RE: REHABILITATION AND UPGRADING OF MUSOMA AIRPORT, TENDER No. AE/001/2017-18/HQ/W/49

Sub: Clarification No. 1 and Addendum No. 2 to the Tender Documents

REHABILITATION AND UPGRADING OF MUSOMA AIRPORT

Addendum No. 2 to the Tender Documents

Appendix 1: Energy Centre – Light Layout for the proposed Substation Building

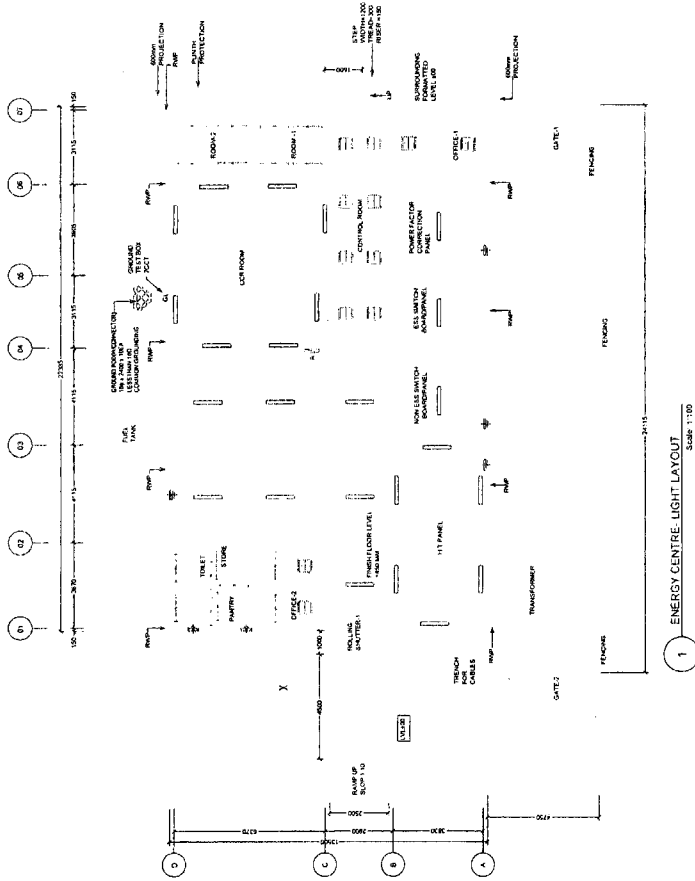
Amend the Section VII: Drawings by adding Energy Centre – Light Layout for the proposed Substation Building attached as **Appendix 1**.
